# Service Bulletin

Subject: INCREASED PERFORMANCE OF GT750

Bulletin No:_	GT-7
Date: May	1, 1975
	Read and Initial
Manager	
Parts	
Service 199

#### IV. Clutch Cork Plates:

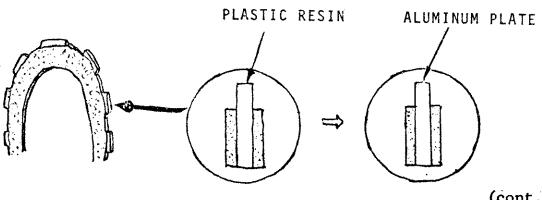
The clutch cork plate's base material has been changed from plastic resin to aluminum.

Lower Crankcase
Right Rear
Section

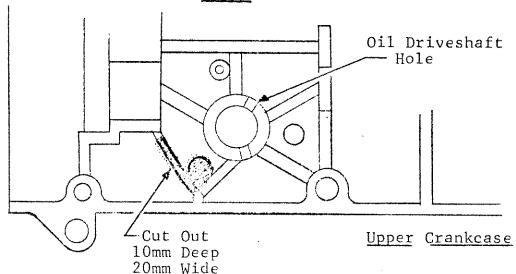
To increase the transmission oil capacity of GT380's prior to the 1974 "L" model to 1500cc, a rubber flashboard must be applied to the primary oil transfer chamber located near the right rear of the lower crankcase half. The flashboard is now available from U. S. Suzuki's Parts Department and its use is strongly recommended whenever the crankcases are disassembled.

The flashboard in position is shown below.

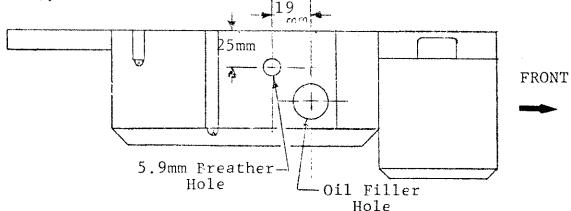
- 1. Clean the surface on which the flashboard is to be applied.
- 2. Apply a quick setting adhesive (such as Suzuki Thread Lock, Loctite, etc.) on the mating surfaces of the flashboard and the chamber wall.
- 3. To assure that oil reaches the primary case you must cut the adjacent rib of the upper crankcase as illustrated below.

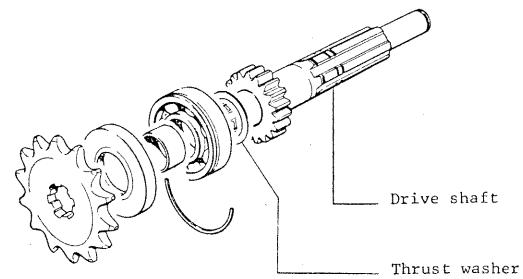
Top gear, driven, on the subject models has been increased in thickness and strength.

When using the new style driveshaft #24131-18002 with old style crankcases, the thrust washer #08211-22341 must be eliminated.

In the event that new cases are fitted and the old driveshaft re-used, washer #08211-22341 must be retained.
